Access Compliance Report

Public Rights-of-Way

Intersection ID: 20865	Main Street: SIMSBURY_RD	Cross Street: VALENCIA_TR	Location: SE
ADA ID: 9A279627690E	Ramp Type: PerpDiag	Initial Pass/Fail: Fail	Overall Compliance: No
		Severity Score: 72.5

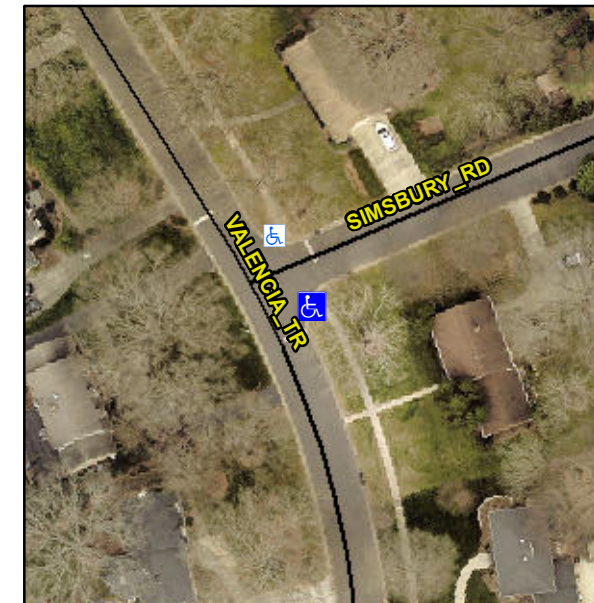
R304.5.1, R304.2.2, R304.5.3

Compliance	Description	Data	Compliance	Description	Data
N/A	Ramp Length (in)	43.0	No	Ramp Slope (%)	8.6
No	Ramp Width (in)	30.0	No	Ramp XSlope (%)	7.6
N/A	Flare Type LT	N/A	N/A	Flare Type RT	N/A
N/A	Flare Slope LT (%)	N/A	N/A	Flare Slope RT (%)	N/A
N/A	Flare Traversable LT?	N/A	N/A	Flare Traversable RT?	N/A
N/A	Landing Length (in)	N/A	N/A	DWS Provided?	N/A
N/A	Landing Width (in)	N/A	N/A	DWS Contrast?	N/A
N/A	Landing Slope (%)	N/A	N/A	DWS Length (in)	N/A
N/A	Landing X Slope (%)	N/A	N/A	DWS Full Width?	N/A
N/A	Landing Curb? (Y/N)	N/A	N/A	DWS Offset (in)	N/A
N/A	Shared Landing?	N/A			
N/A	Gutter Ponding?	N/A	N/A	Gutter Slope (%)	N/A
N/A	Gutter Lip Ht (in)	N/A	N/A	Gutter X Slope (%)	N/A
N/A	Painted X Walk1?	No	N/A	Painted X Walk2?	No
	X Walk 1 Direction	To N		X Walk 2 Direction	To W
N/A	X Walk 1 Width (in)	N/A	N/A	X Walk 2 Width (in)	N/A
	X Walk 1 Slope (%)	2.1		X Walk 2 Slope (%)	3.1
	X Walk 1 X Slope (%)	4.9		X Walk 2 X Slope (%)	4.8

Remove & Replace Curb Ramp With Two New Directional Ramps or Equivalent.
